ANKENY COMMUNITY SCHOOL DISTRICT

Facilities/Finance Committee Meeting

Title: Construction Change Orders

Facility Construction Change Orders

1st North looking South at Raised Floor. Looking at 14 Line.

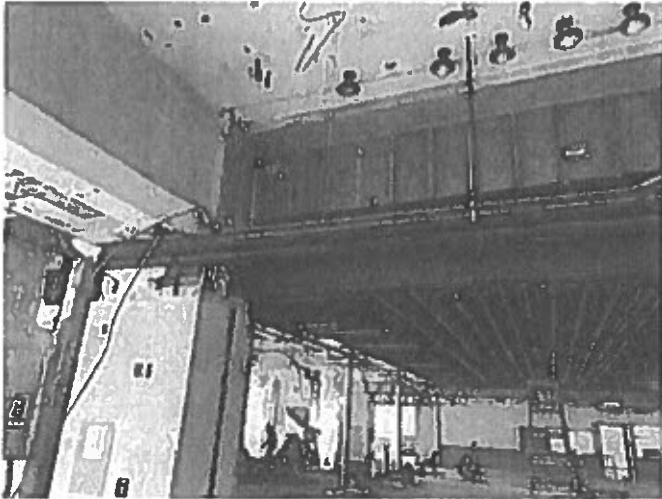
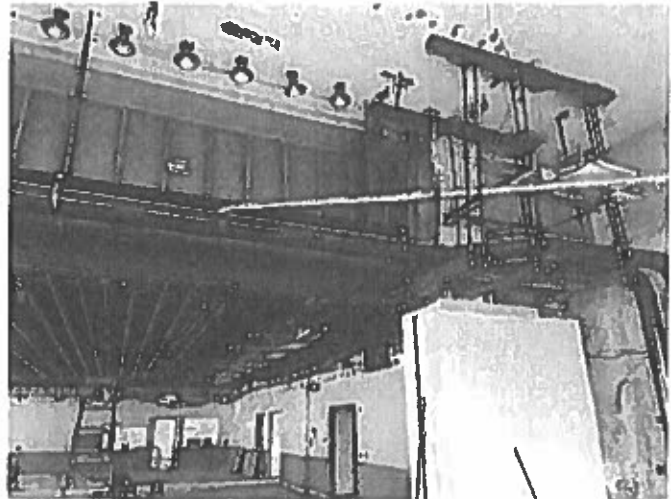
Description	QTY	Units	Labor	Labor unit	Material	Material unit	EQ	Sub	Total Amount
Scrape and remove glue pucks and fiber tiles.	2956	Sq Ft	\$0.45	per sq ft					\$1,330.20 \$0.00
Remove Fiber Tiles Only	3103	Sq Ft	\$0.20	Per Sq Ft					\$620.60 \$0.00 \$0.00 \$0.00 \$0.00 \$0.00 \$0.00 \$0.00 \$0.00
Multiple locations on 1st and 2nd floor. See Attached noted sheets.									
Subtotals									\$1,950.80
Material Sales Tax	0.00%								\$195.08
Labor Burden	10.00%								\$39.02
Small Tools	2.00%								\$19.51
Expendables	1.00%								\$253.60
Subtotals									\$22.04
GL Ins.	1.00%								\$2,226.45
Subtotal:									\$2,226.45
O&P 5%:									\$111.32
Total Net cost:									\$2,337.77

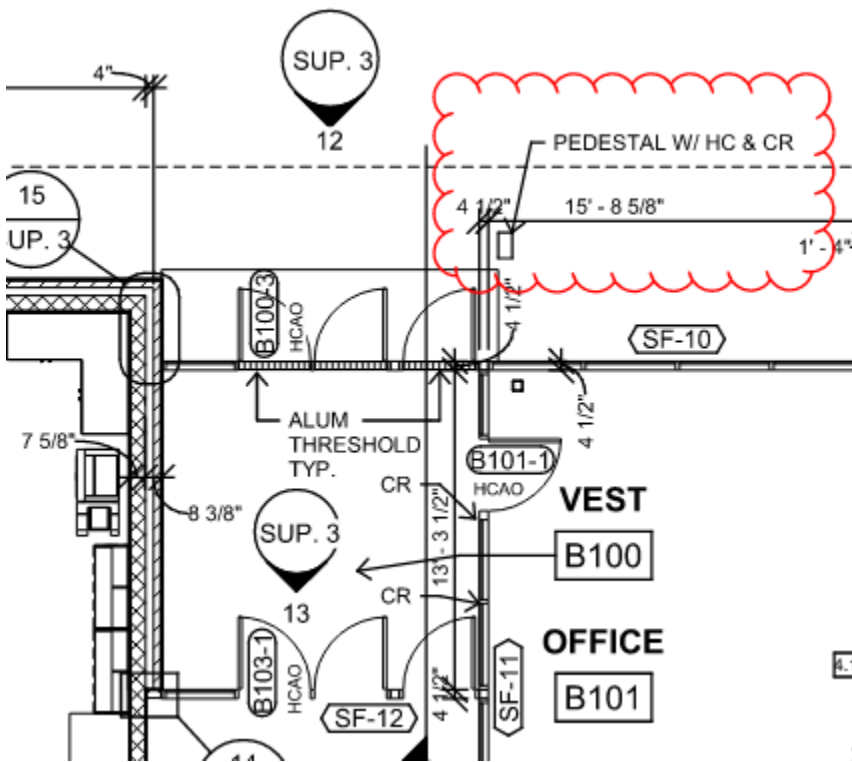
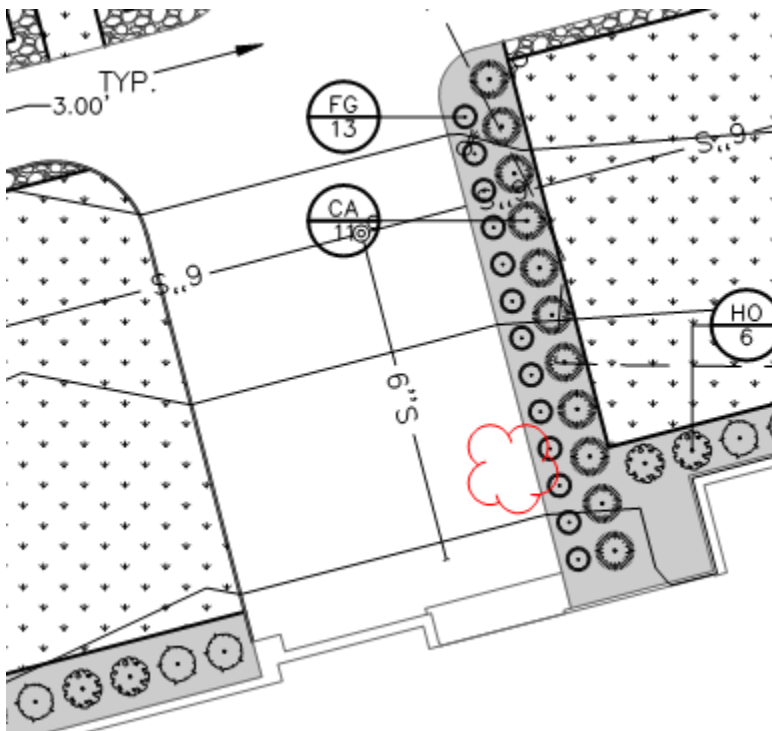
Mike, they are moving the card reader on door B100-3 per this PR to be installed on the provided pedestal. The CR is owner provided and installed we are just installing a raceway for them. We will make a note on our plan to move the raceway to this revised location noted at no additional cost. Please make sure whoever is supplying the Pedestal has a cut out for the HC operator and the CR.

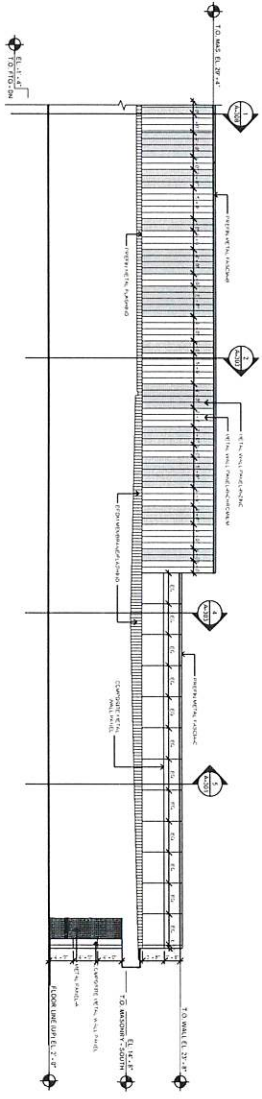
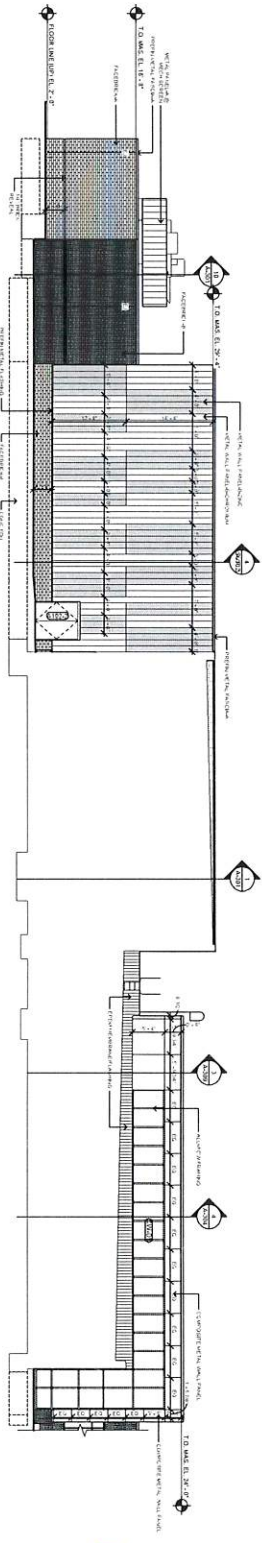
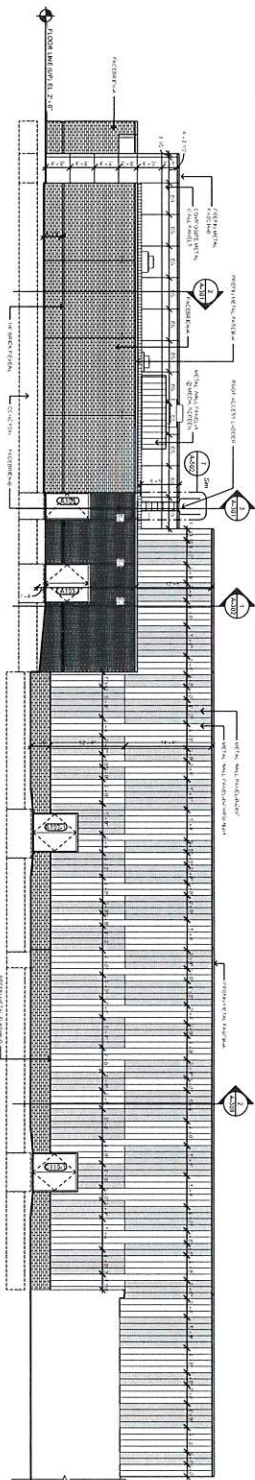
- Sheet A-201: Modifications to elevation 4/A-201.
- Sheet Supplemental 3: Add section 1/A-301 to list of similar conditions under 2/SUP. 3.
- Sheet Supplemental 3: 6/SUP. 3 is no longer used in the project.

- Replace metal panel with brick at main entrance. See attached elevations and plan.
- Modify SF-10 and SF-12 to accommodate change in overall width. See sheet Supplemental 3.
- Move pedestal with handicap hardware to east side of pavement. Move card reader from exterior wall to pedestal.

Note: Doors B100-1 & B103-1 quantity change to 3.

DRAWING NO.
A-202

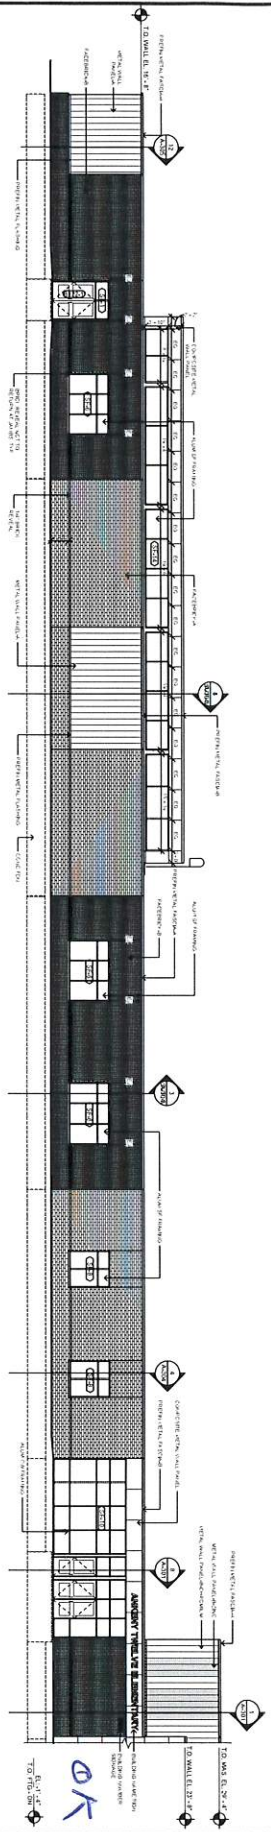
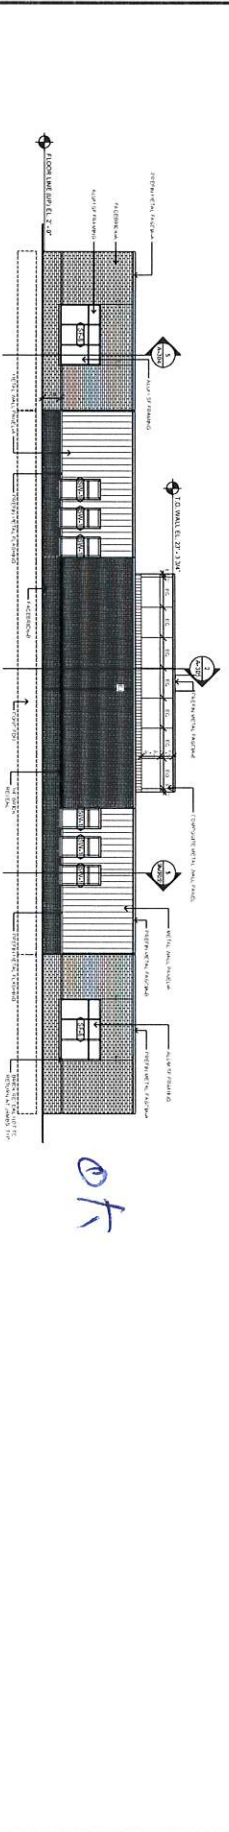
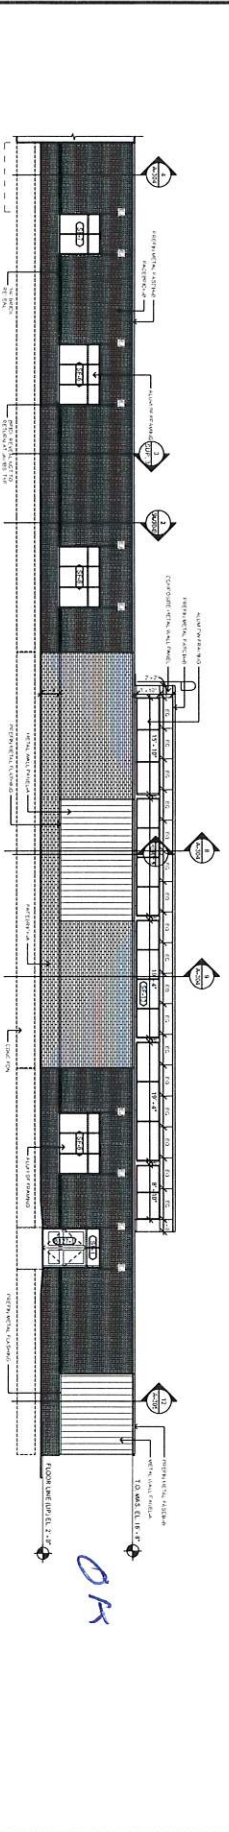
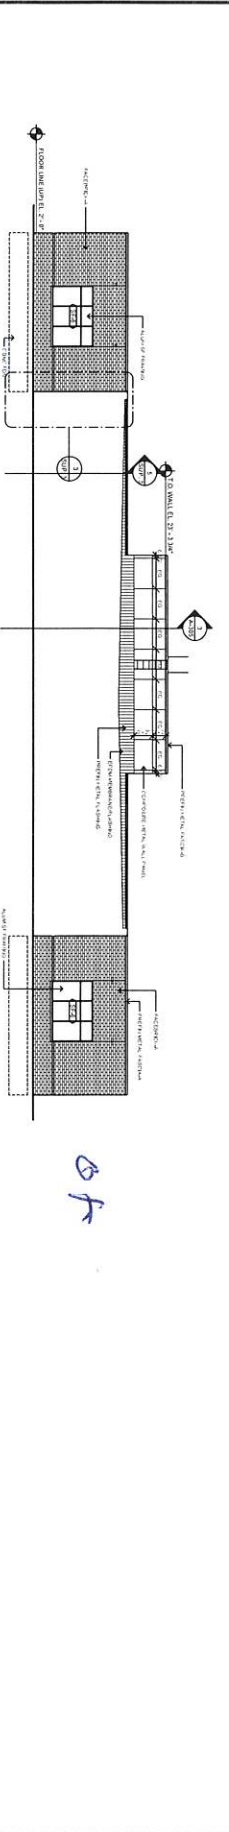
- Revised Exterior Elevations: Sheets A-201, A-202, A-203 & A-204
- Sheet Supplemental 3
